## **East Midlands Gateway Phase 2 ISH 3 Wednesday 13th May and Thursday 14th May 2026**

### **Summary of Verbal Representations from Protect Diseworth (PD)**

**Table 4: Modelled Traffic Flows on A453 East of Site Access/passenger car units (pcu)**

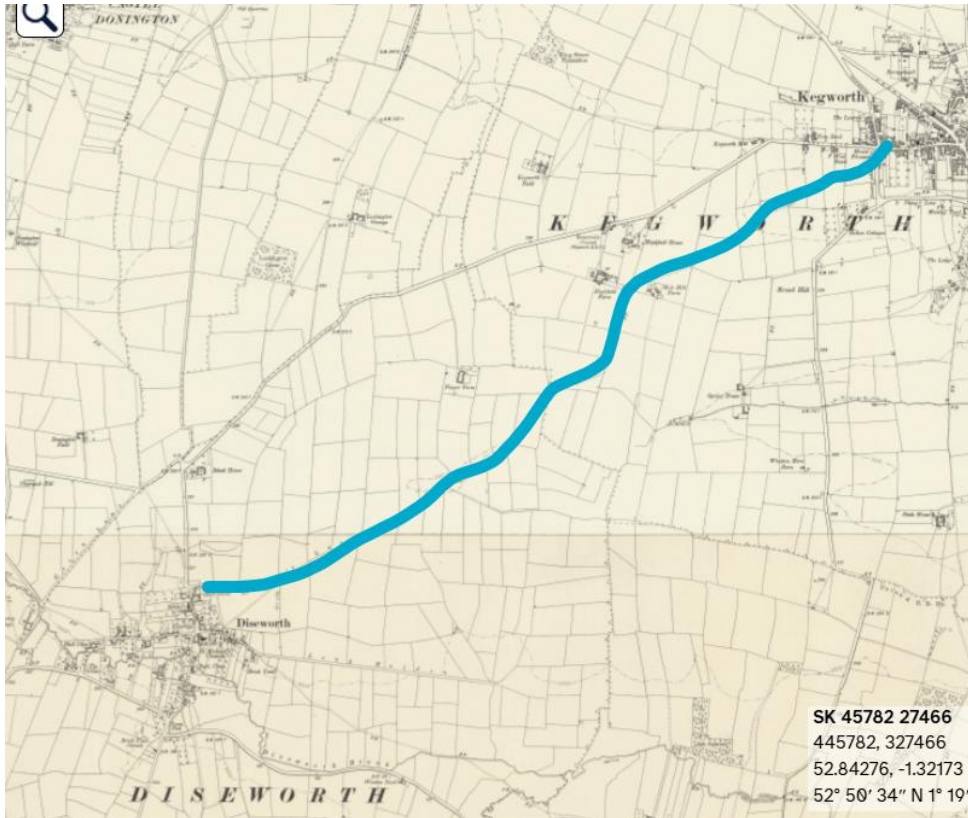
25. The red shaded cells identify where the predicted flow on the A453 exceeds the saturation flow (1,650 pcu – see pdf p.100 of REP1-058) assuming vehicles face a red signal at the crossing for 8 seconds every 240 seconds. The orange shaded cells show further situation where the link would be over capacity if vehicles were stopped for 21 seconds every 240 seconds. It is clear that in many scenarios the A453 is predicted to operate above maximum capacity (flows in excess of 1,550 or 1,650 vehicles). If the crossing were to be called more frequently than once every 4 minutes, there would be a further reduction in capacity.

26. It is concluded that the modelling, predicated on a very low level of pedestrian and cycle movement, is incorrectly accounted for in the traffic modelling. The modelling that has been undertaken indicates that the A453 would operate over capacity in several of the modelled scenarios. If the operation of the Toucan crossing were to be properly accounted for in the modelling and the frequency of use of the crossing increased, the degree and frequency of the A453 operating over capacity would further increase.
